# UNITED STATES PATENT AND TRADEMARK OFFICE

APPLICATION NO.	FILING DATE	FIRST NAMED INVENTOR	ATTORNEY DOCKET NO.	CONFIRMATION NO.
09/800,006	03/06/2001	James C. Rush	STE01 P-1086	5256

# Office Action Summary

## DETAILED ACTION

FIG. 24

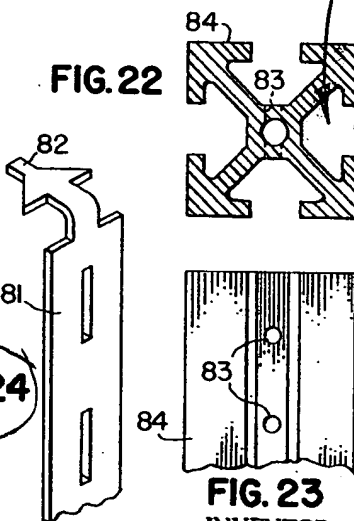
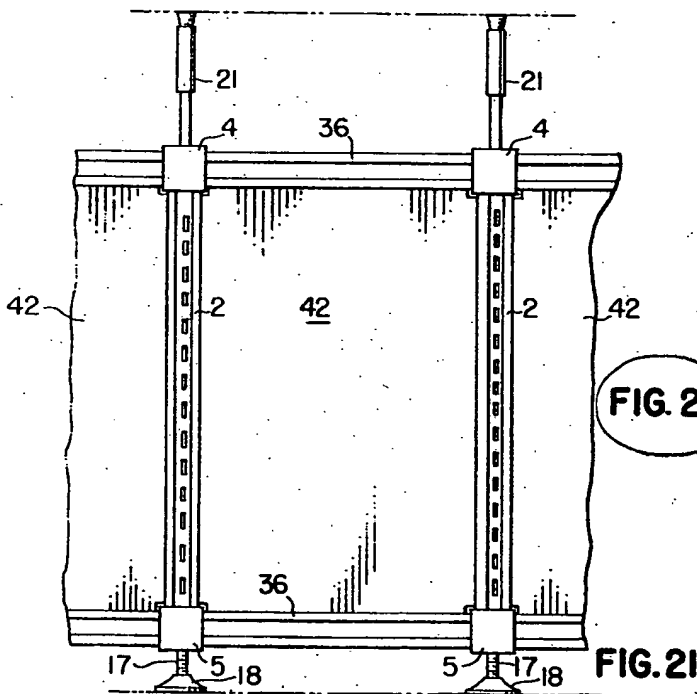
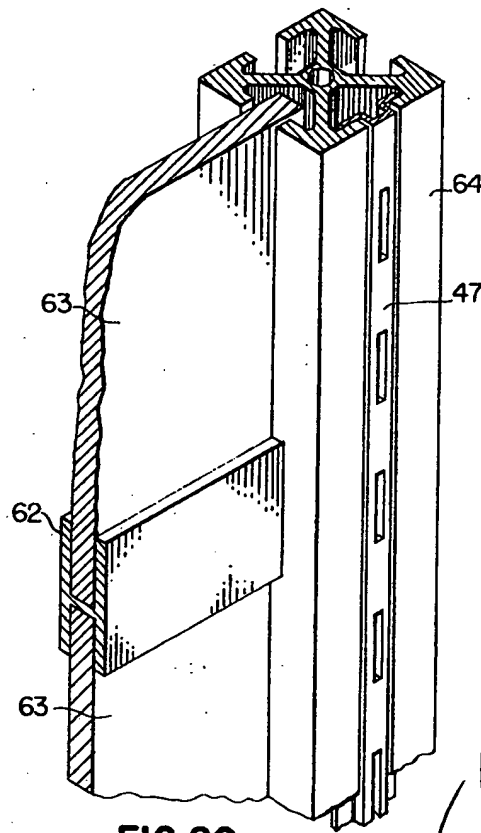
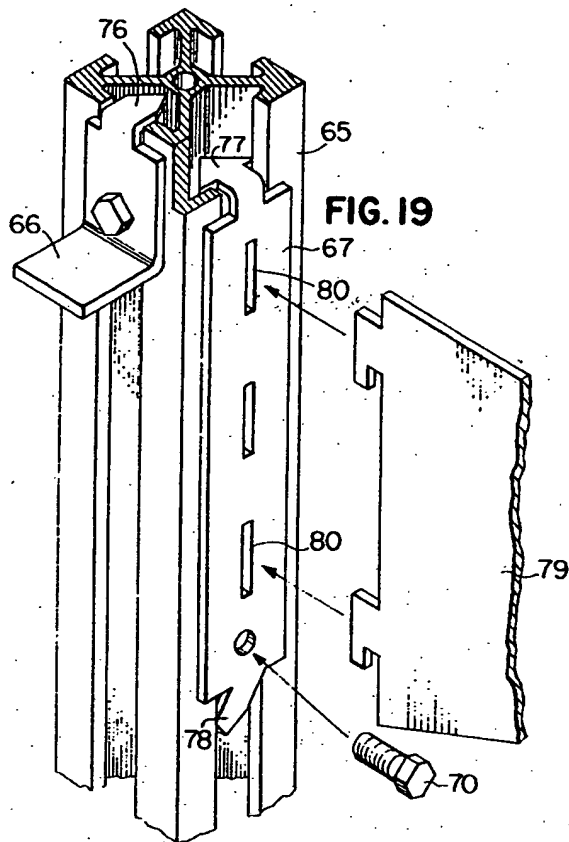
6. Claims 1 and 27 are rejected under 35 U.S.C. 102(b) as being anticipated by US Patent #3,513,606 to JONES. JONES discloses a furniture system including a plurality of overhead beams (36), a plurality of vertical posts (2) having outwardly extending flanges (FL) and an end face with a vertical central slot (3), and a plurality of connectors (4,40). The slots (3) are

generally T-shaped with an enlarged interior track portion (IT) and a reduced neck portion (N) and the connectors (4,40) are shaped to be received within the slots (3). The overhead beams (36) have slots (37) in a lowermost face thereof, see attachment. Regarding claim 27, the vertical posts (20) include hollow bases (5) with adjustable leveling telescoping feet (F), see attachment.
